Re: The Village at Saddlerock Crossing – PZ19-00005 (ZC, DEV) – LOI Comment Responses

RESPONSE TO CITY COMMENTS ON
PRELIMINARY LANDSCAPE PLAN for :
THE VILLAGE AT SADDLEROCK CROSSING
PZ19-00005 (ZC, DEV)

SITEPLAN

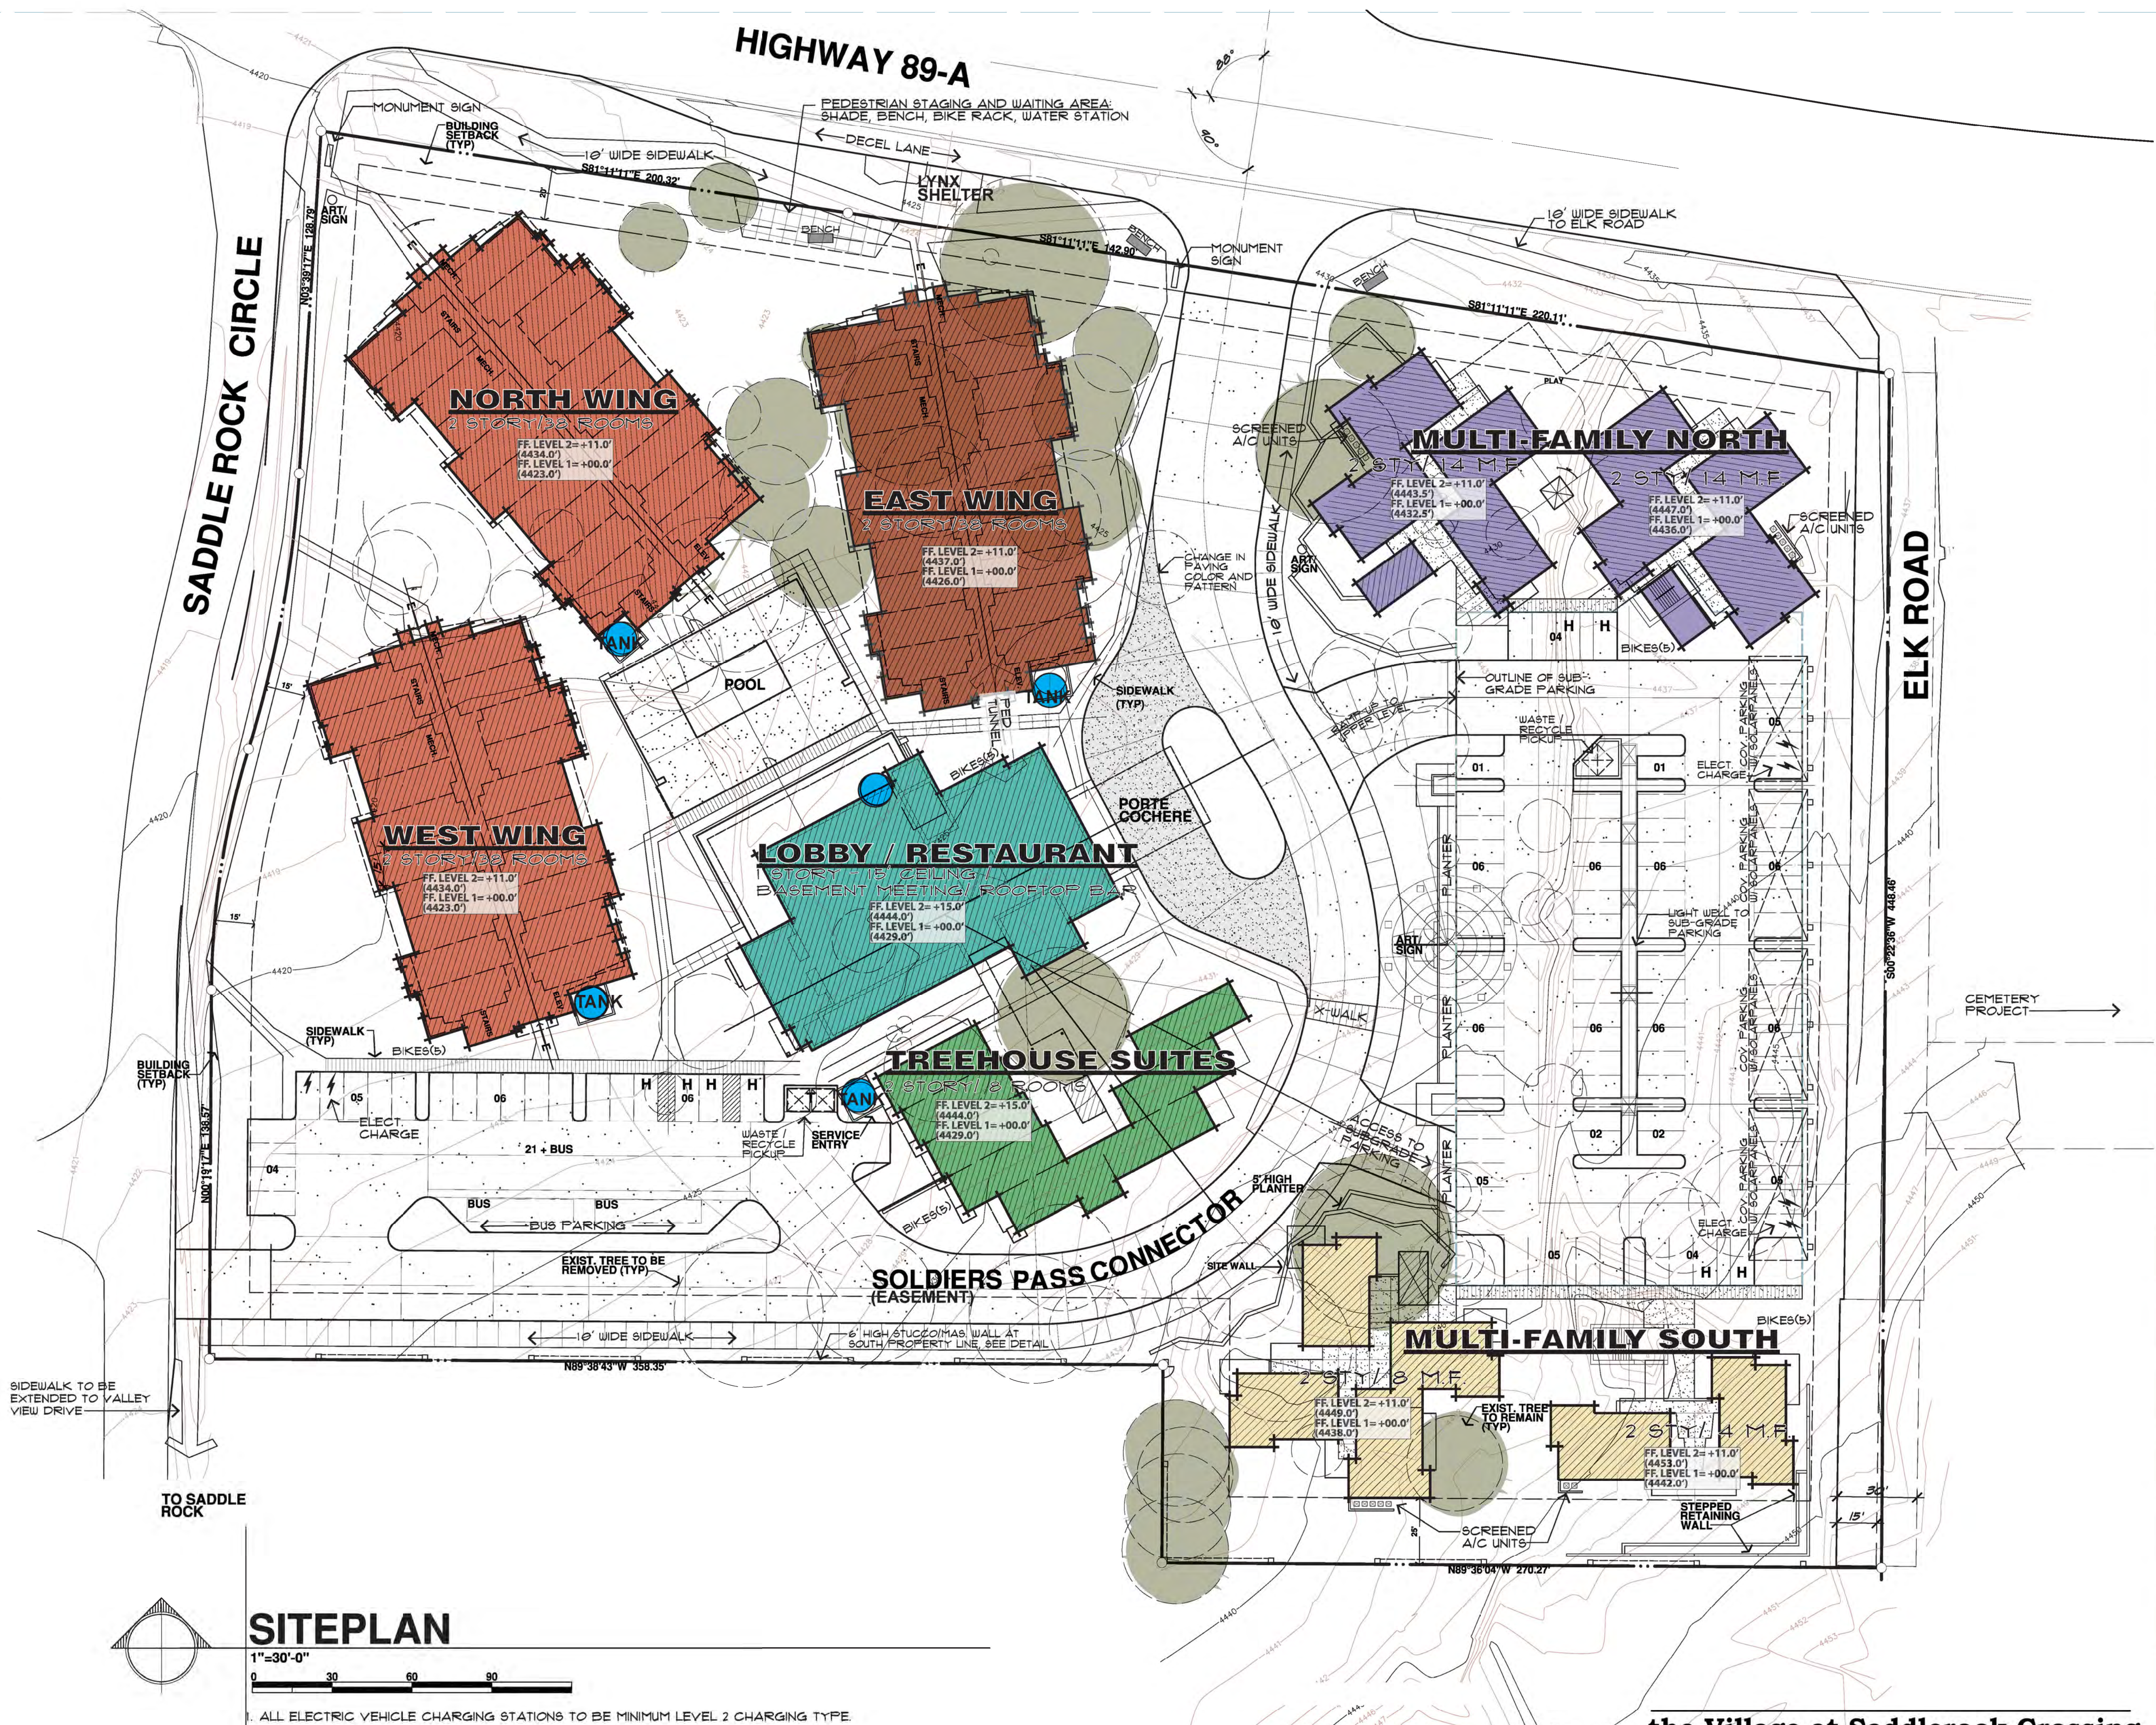
- ii) Previous plans showed a connection to Elk Road, which does not appear to be on the current plans. A connection to Elk Road (either vehicular or pedestrian) is needed to address the CFA goal of coordinated development.

- iii) Continuation of the sidewalk along Saddlerock Circle to Valley View Drive should be considered by the applicant.

Electric vehicle charging should be provided for both the residential and lodging uses. For this project, the spaces should be EV-built (not only capable) and provide Level 2 charging capabilities.

- (1) A deceleration lane for eastbound State Route 89A traffic is not shown on the site plan.

- (4) Pedestrian Connectivity: Provide more details (perhaps amend the Circulation Plan) to show where proposed pedestrian amenities such as patterned crosswalks and shaded rest areas will be located, including crosswalks across the connector road.

Response: Site plan has been revised to show a pedestrian connection from the project to Elk Road.

Response: Site plan has been revised to extend sidewalk to Valley View Drive.

Response: Site plan and narrative updated to reflect incorporation of six (6) Level 2 charging stations throughout site.

Response: Site plan revised to show deceleration lane.

Response: Site Plan updated to indicate location of crosswalk across connector road and shaded pedestrian staging area adjacent to SR-89A.
